**Request for Additional Information No. 335 (4059, 4061)
Question 03.08.04-10, Revision 1**

U. S. EPR Standard Design Certification

Question 03.08.04-10:**Follow-up to RAI Question 03.08.04-5**

Figure 03.08.04-10-1—Hydrodynamic Pressure on SFP Walls due to Seismic Load in -Z (vertical down) Direction

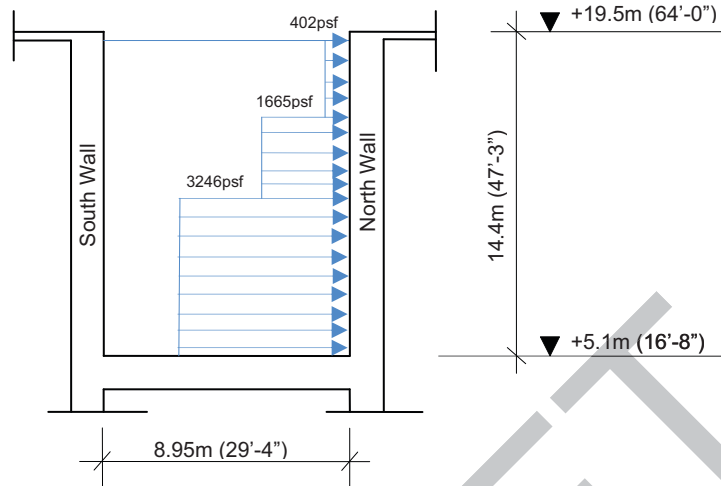
Elaborate on how the hydrodynamic loads are determined and provide a summary of the relevant calculations for the spent fuel pool. This summary should include the magnitude of convective and impulsive masses, corresponding frequencies, and a description of the methodology used to convert the dynamic effects of these water masses to loads applied to the static FE model. Confirm if the same methodology is used for the other seismic Category I pools in the U.S. EPR.

- Hydrodynamic pressure on SFP walls and slab resulting from seismic load in Z (vertical up and down) direction are calculated by multiplying the pool slab ZPA in the Z direction and the mass of the fluid. The magnitude of the calculated and applied uniform pressure on the pool slab is 4222 psf. The pressure on the walls is calculated using 3.28 ft (1m) increments and has a magnitude of 152 psf at the first increment near the water surface, and 4086 psf at the last increment at the bottom of the pool. The loads from each increment are separated to three bands, and the pressure is averaged over the band height, and applied as a uniform wall pressure over the band heights. Figure 03.08.04-10-1 shows the application of the uniform pressure on the walls in the static model.
